HORSHAM DISTRICT COUNCIL CONSULTATION

TO:	Horsham District Council – Planning Dept
LOCATION:	Broomers Hill Park Broomers Hill Lane Codmore Hill West Sussex
DESCRIPTION:	Variation of conditions 19, 20, 22, 23, 24, 30, 31, 36, 38, 39, 40, 42 and 43 of previously approved application reference DC/13/1048 (Proposed development of 10 No. B1/B8 units with 55 parking spaces, 2 disabled spaces & 10 LGV parking spaces and outline consent for a further B1/B8 unit with 10 car parking spaces) to combine the two approved buildings into one single building.
REFERENCE:	DC/26/0975
RE-CONSULTATION:	1 st set of comments in black 2nd set of comments in blue
RECOMMENDATION:	Modification Modification

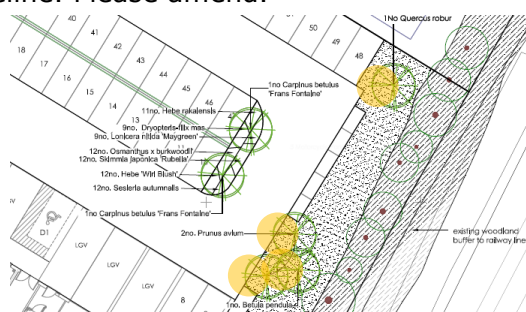
1. We recommend that chemical fertilisers, pesticides and herbicides including glyphosate are not to be applied at any time due to impacts on existing and proposed ecological features.

This is also in line with objectives found within the Sustainability Statement. Alternative methods for weeding should be considered, except for Schedule 9 species; please refer to pan-uk.org for guidance and [resources](#). Please amend the "TREATING TOPSOIL" and "GENERAL TOPSOIL STORAGE" sections accordingly.

Amended, with thanks. Closed.

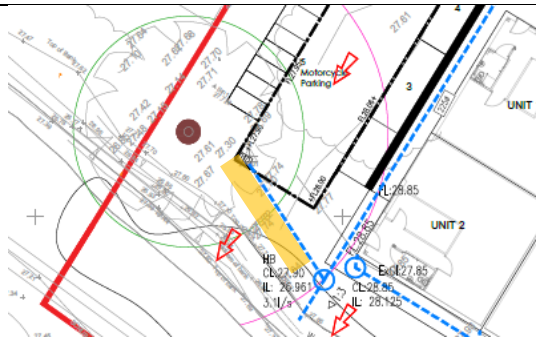
14. Please adjust this drainage run (highlighted in yellow) to avoid the RPA of English oak T4, if possible, to safeguard its retention.

15. Please note in addition that this encroachment within the RPA and beyond the Tree Protection Fencing is not reflected within the Arboricultural Impact Report or Tree Protection Plan. Therefore, if it cannot be altered, the advice of HDC's Arboriculturalist should be sought.

Drainage run adjusted, with thanks. Closed.

As above, closed.
